**Technical Service
Information Bulletin**

TONNEAU COVER LATCH RATTLE

'04 – '06 RX 330, '06 – '07 RX 400h, &
'07 RX 350

NVH
NV001-07

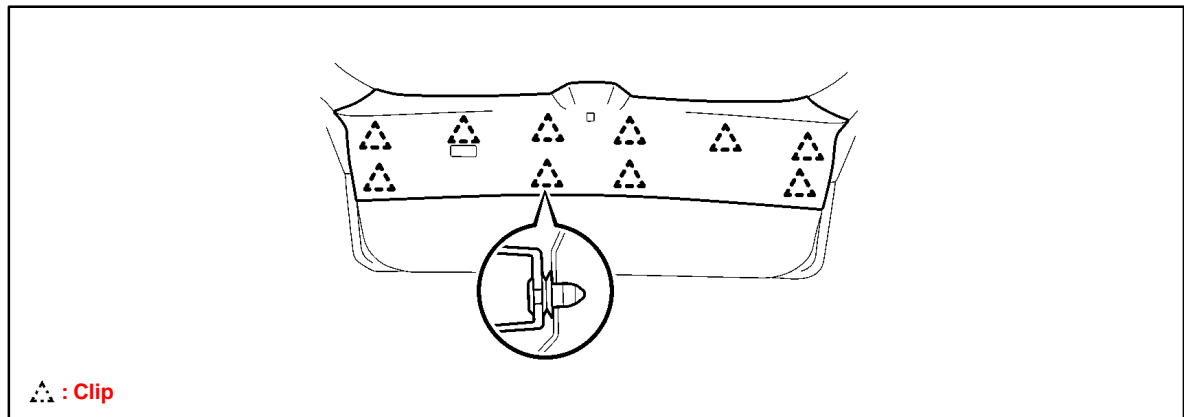
Introduction Some customers may experience a rattle noise from the rear of the vehicle when going over bumps. This problem is due to lack of insulation and excessive clearance between the tonneau cover locks and the back door trim spacers. Perform the following procedure to correct this condition.

PREVIOUS PART NUMBER	CURRENT PART NUMBER	PART NAME	QTY
67754-48010-##	67754-48050-##	Spacer, Back Door Trim RH	1
67754-48020-##	67754-48060-##	Spacer, Back Door Trim LH	1

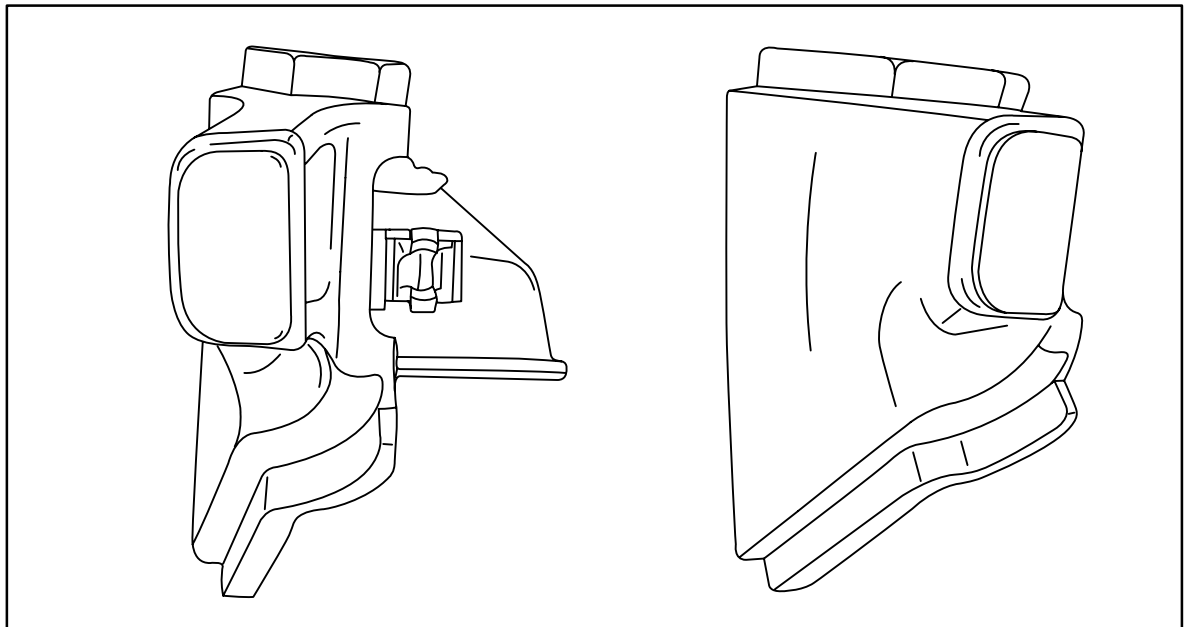
3. Remove the screw and then remove the back door trim spacer RH and LH.

4. Replace the back door trim spacer RH and LH with a NEW one.
